Subject: [FIXED] Beam pipe valves?

1) [viewer.gif](#), downloaded 981 times

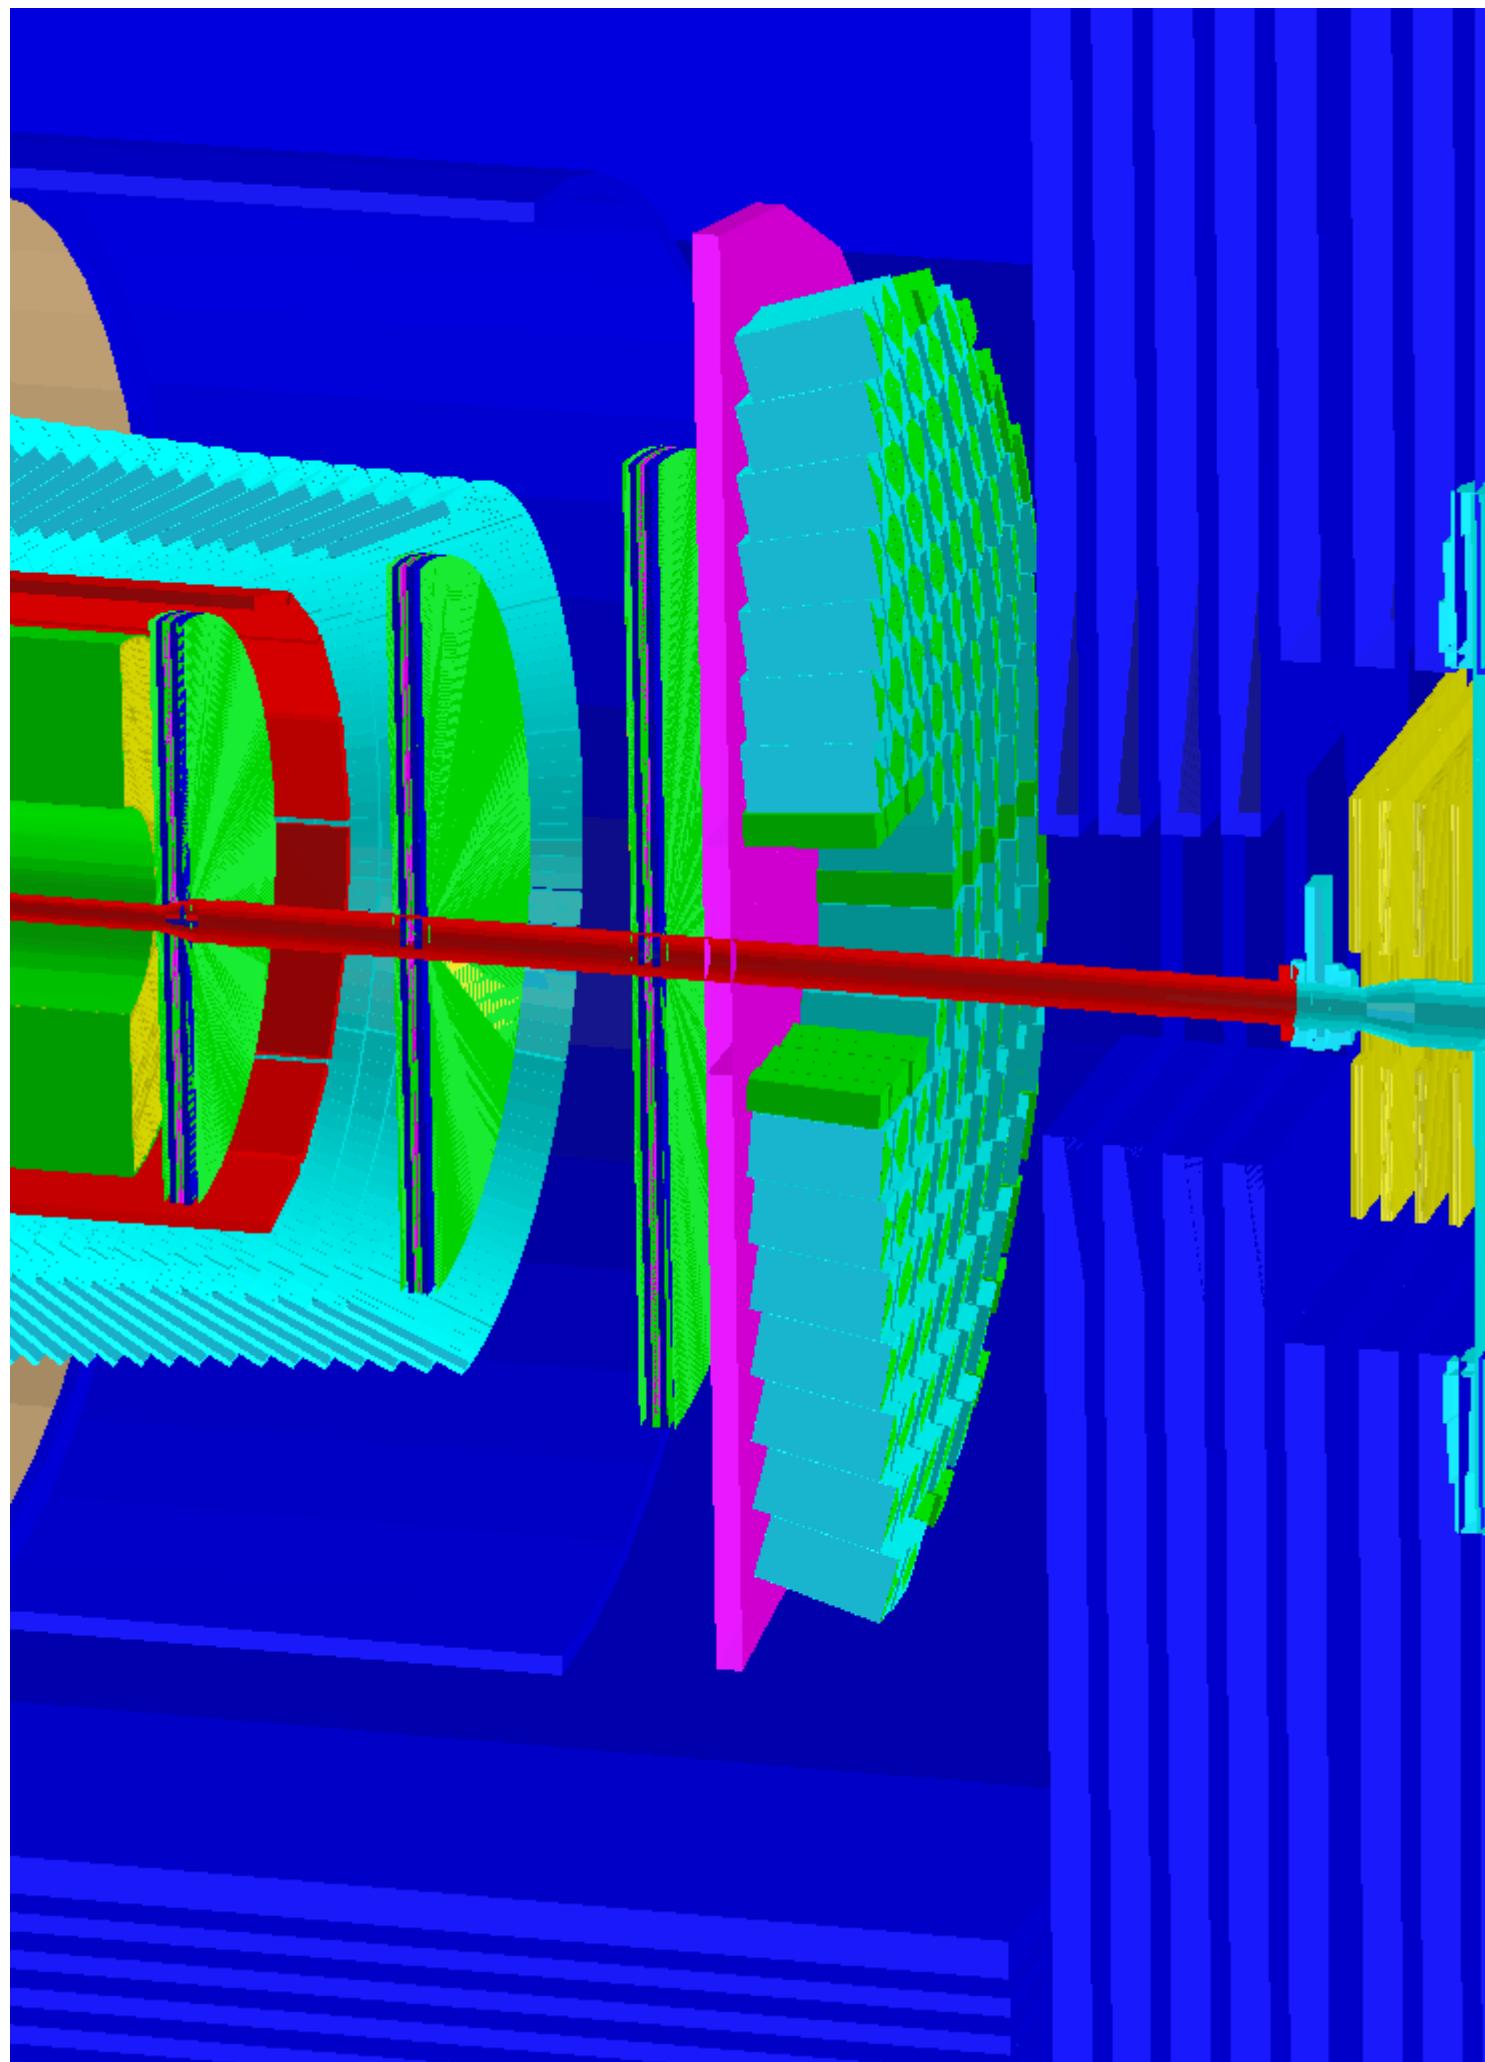
In the OGL drawing you can see that the pipe has a sort of "tower" which is in the middle of the muon filter. I am wondering what is wrong there, if the "tower" should be really there, if maybe the muon filter should be modified to host it, or if maybe we have some geometry problems.

Indeed, this is the first pumping station downstream of the target. The description corresponds to what is to be found on EDMS since several years. So I guess that muon description is not up to date?

Fixed!

Please update your mdt folder, in particular those running analysis on forward tracker.
